**SUBJECT:** **NEW VEHICLE DEMONSTRATION / DELIVERY HOLD -**

**Safety Recall 24S67 - *Supplement #1***

Certain 2023-2024 Model Year Transit Vehicles Equipped with a 9.75 Rear Axle  
Incorrect Bolt Replacement

**New! REASON FOR THIS SUPPLEMENT**

**FIGURE 1**

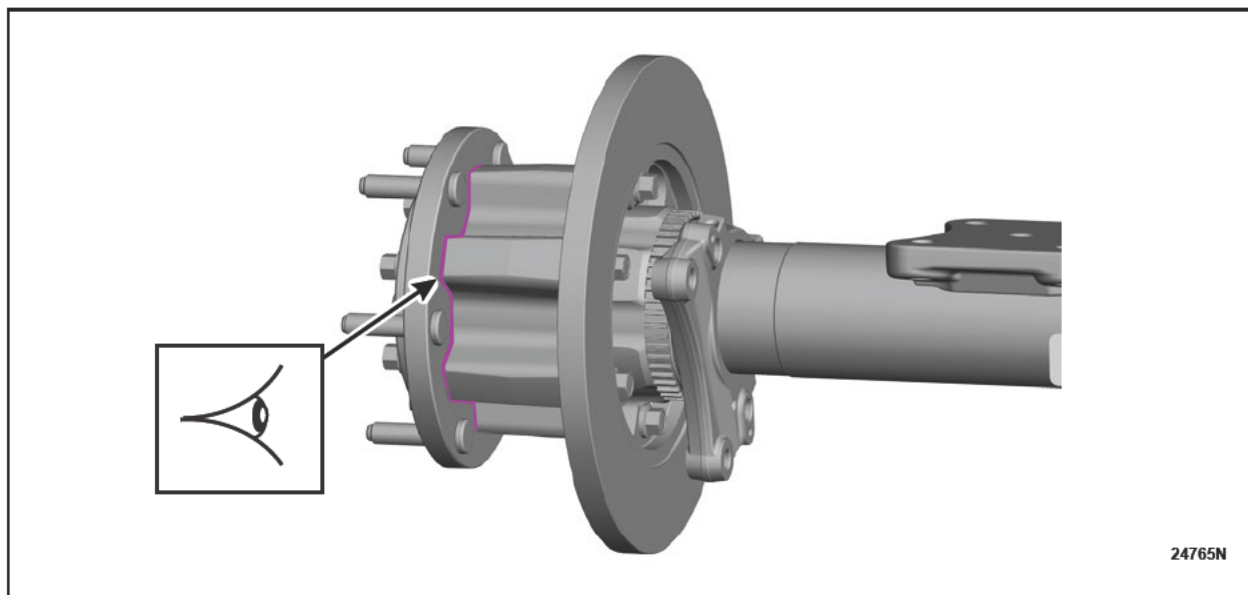
2. Visually inspect both the right hand (RH) and left hand (LH) axle hubs for signs of leaking rear axle fluid. See Figure 1.

FIGURE 2

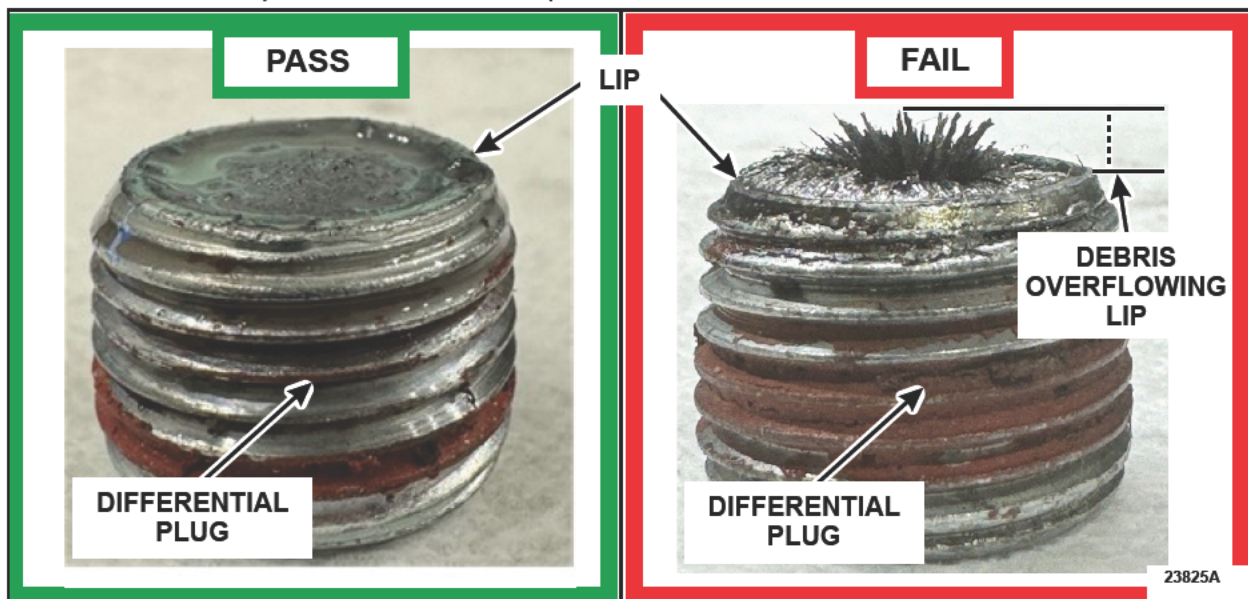
6. Is there metal debris spilling over or extending above the lip of the plug magnet? See Figure 2.

No - Passes FSA Inspection - Proceed to Step 15.

Yes - Fails Inspection - Proceed to Step 7.

FIGURE 4

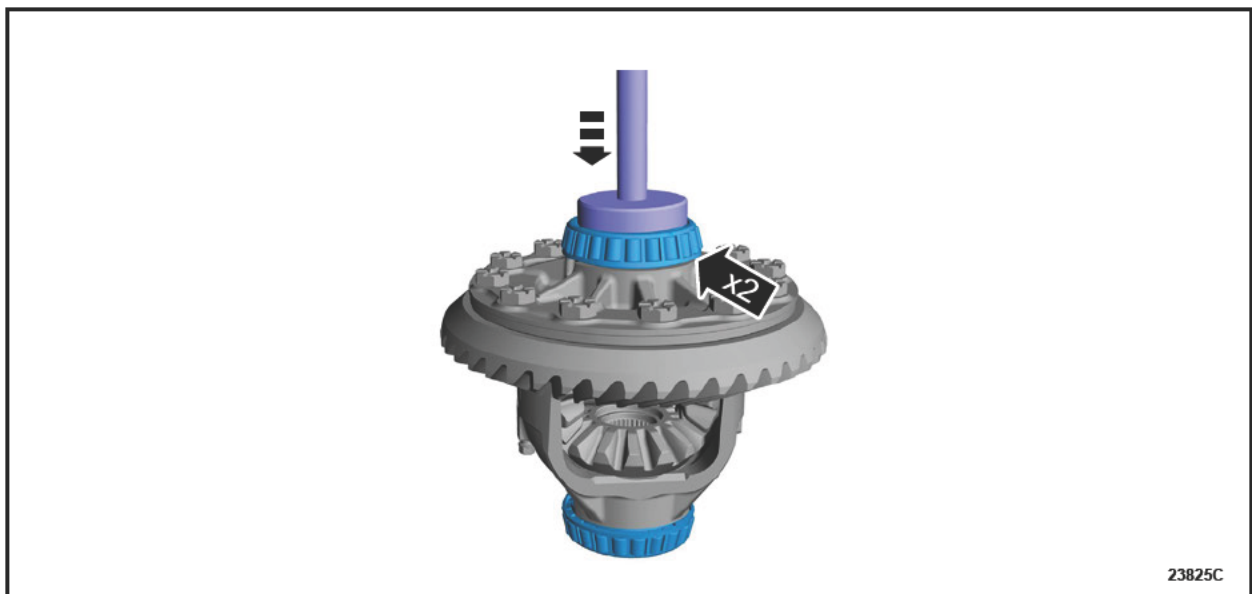
10. Install the new differential bearings. See Figure 4.

- Use Tools: 205-D044 (D81T-4221-A) Installer, Differential Carrier Bearing.

FIGURE 5

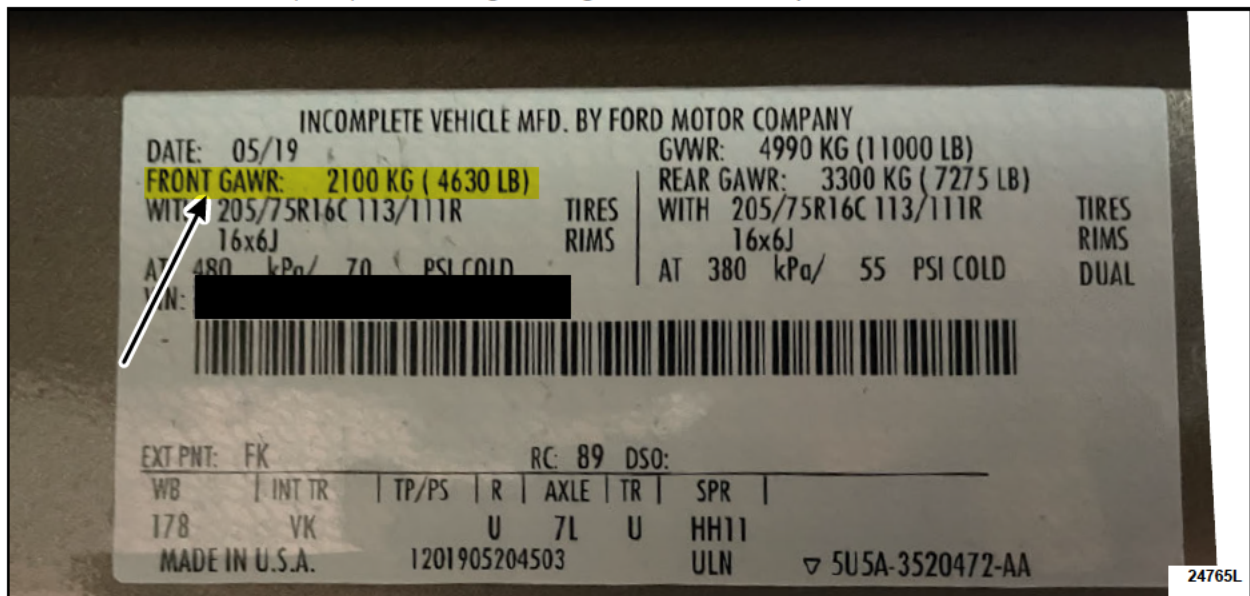
17. Check the Vehicle Identification Number (VIN) sticker located in the driver door jamb to identify the axle the vehicle is equipped with. See Figure 5.

- For SRW Front Gross Axle Weight Rating (GAWR) Maximum - Proceed to Step 19.
- For SRW Front (FRT) Axle Rating 2100kg - Proceed to Step 21.

**FIGURE 7**

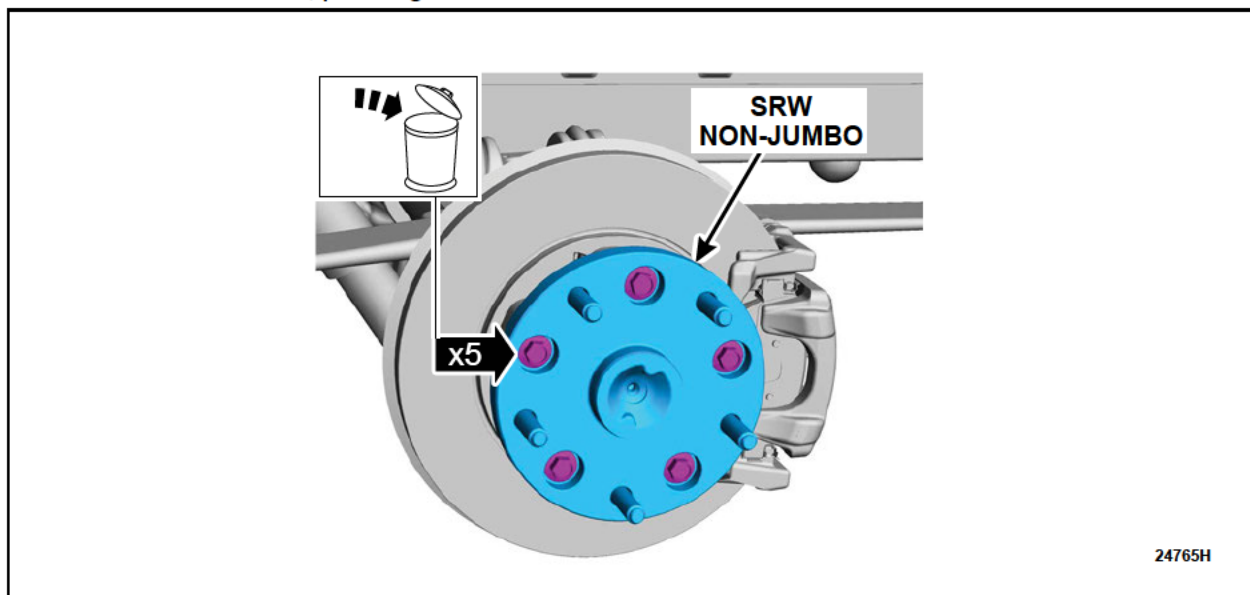
19. On both sides, remove and discard the 5 Axle Shaft Bolts. See Figure 7.

**FIGURE 8**

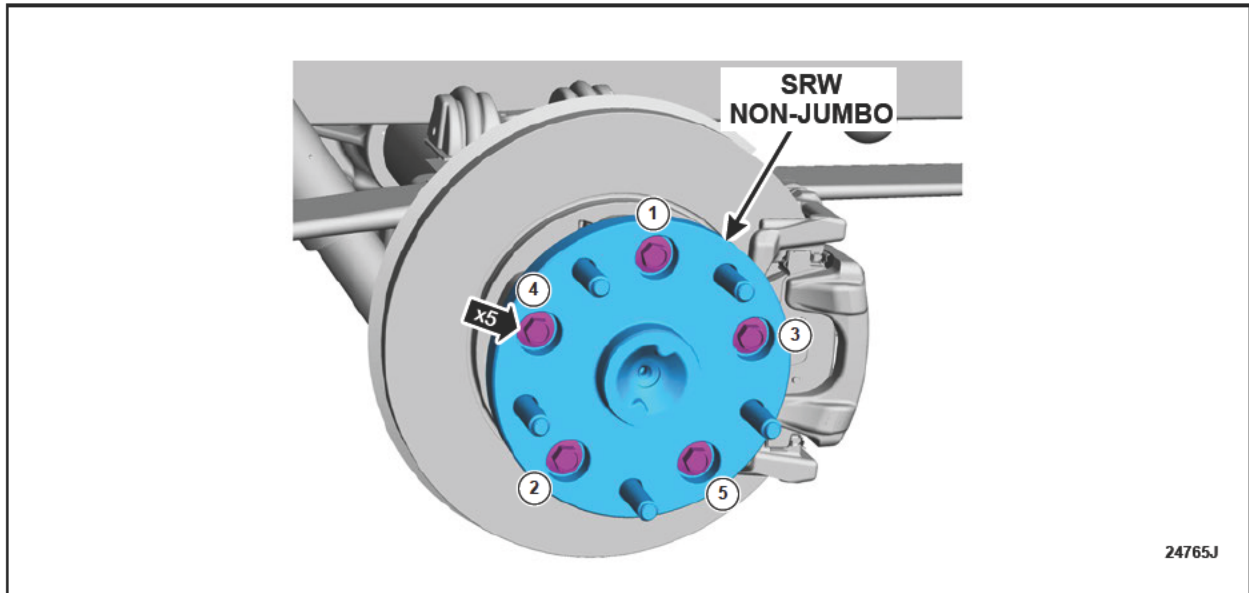
20. On both sides, install 5 *new* Axle Shaft Bolts. Tighten all of the bolts in the sequence as shown in Figure 8. This completes the FSA.

- a. Stage 1: 20 lb.ft (27 Nm)
- b. Stage 2: 50 lb.ft (68 Nm)
- c. Stage 3: 90°

**FIGURE 9**

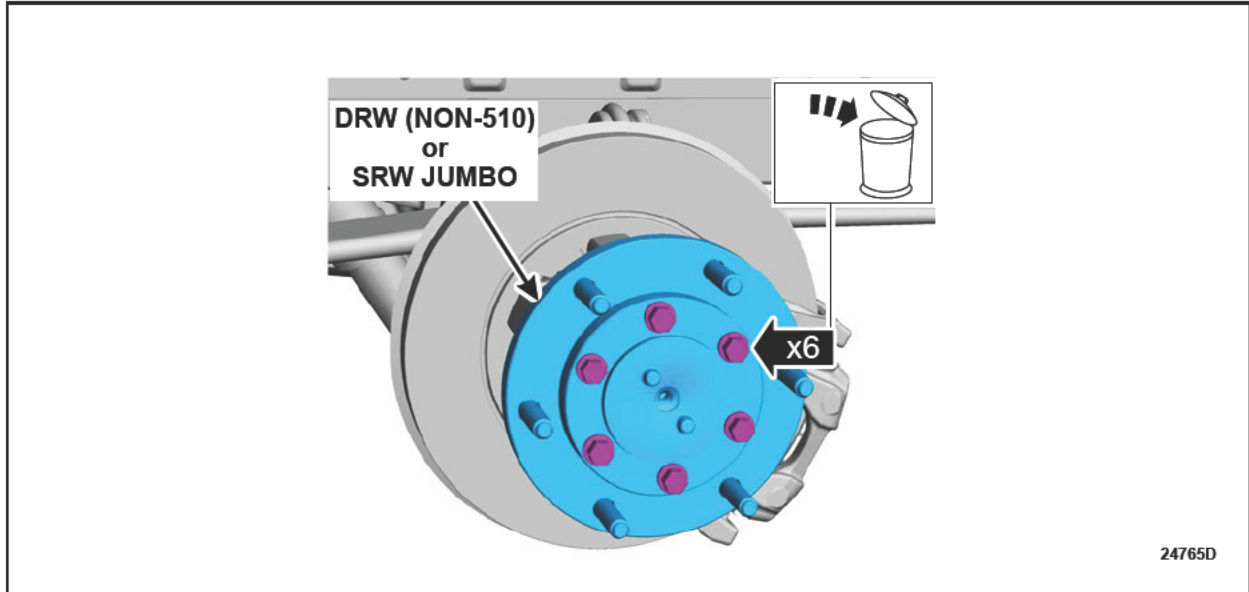
21. On both sides, remove and discard the 6 Axle Shaft Bolts. See Figure 9.

**FIGURE 10**

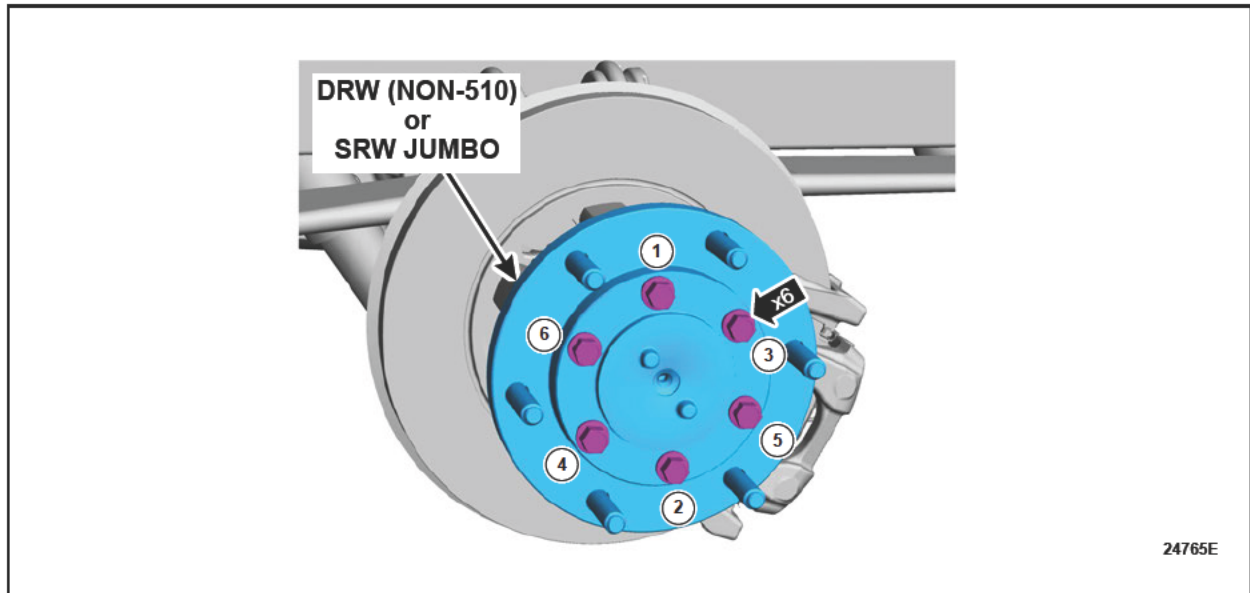
22. On both sides, install 6 *new* Axle Shaft Bolts. Tighten all of the bolts in the sequence as shown in Figure 10. This completes the FSA.

- a. Stage 1: 20 lb.ft (27 Nm)
- b. Stage 2: 46 lb.ft (63 Nm)
- c. Stage 3: 90°

**FIGURE 11**

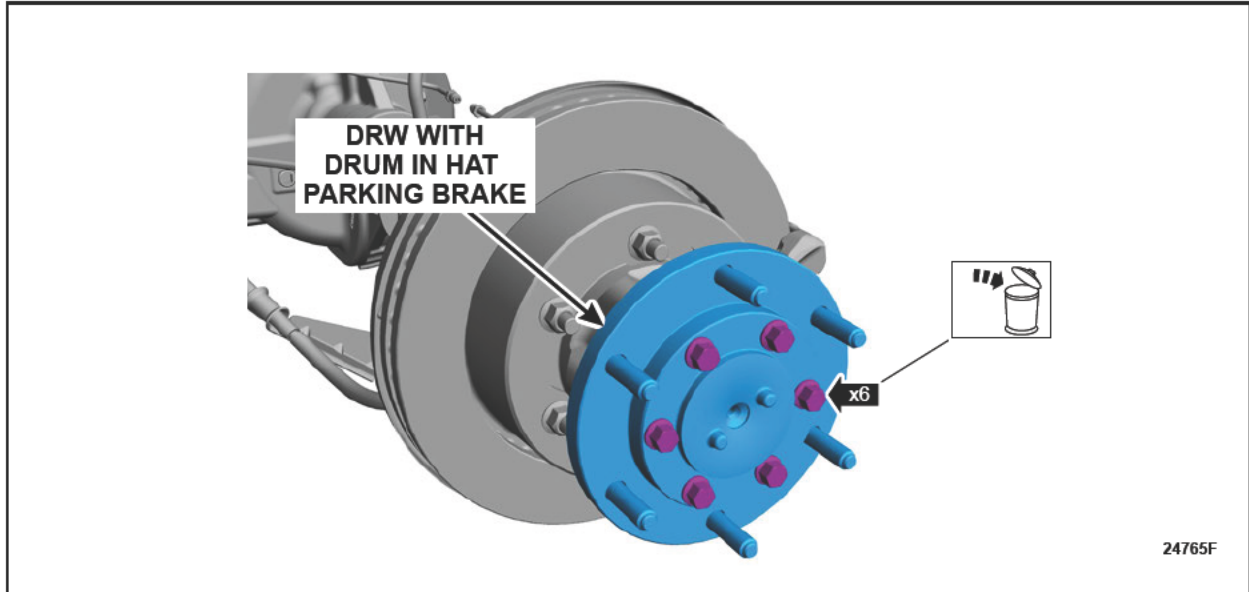
23. On both sides, remove and discard the 6 Axle Shaft Bolts. See Figure 11.

**FIGURE 12**

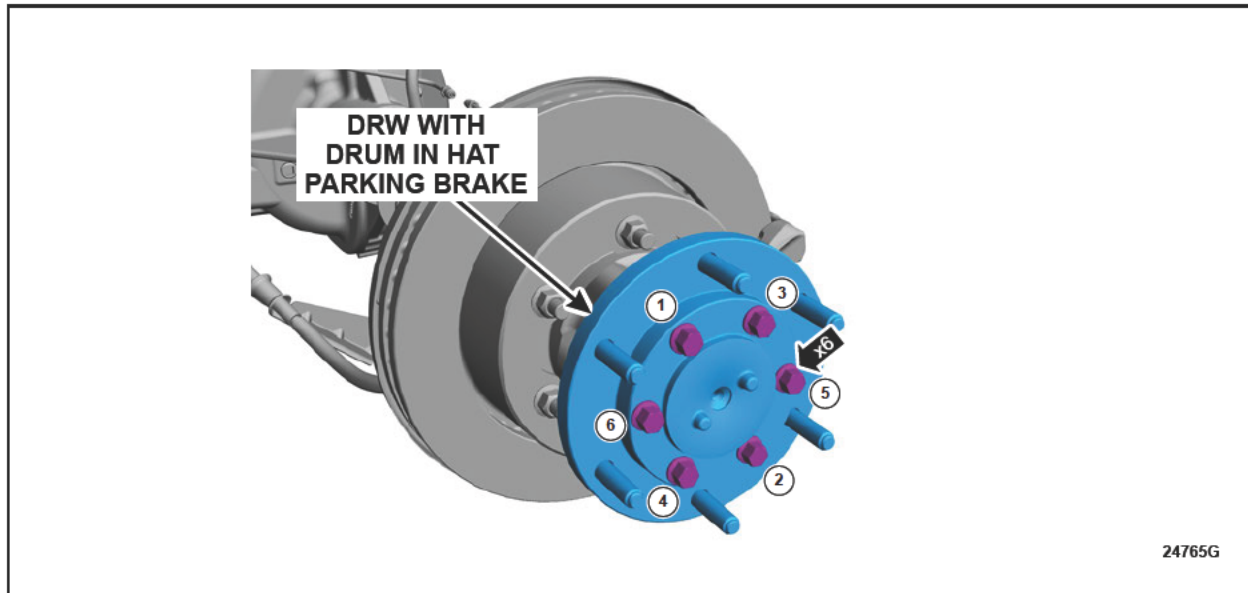
24. On both sides, install 6 *new* Axle Shaft Bolts. Tighten all of the bolts in the sequence as shown in Figure 12. This completes the FSA.

- a. Stage 1: 20 lb.ft (27 Nm)
- b. Stage 2: 46 lb.ft (63 Nm)
- c. Stage 3: 100°
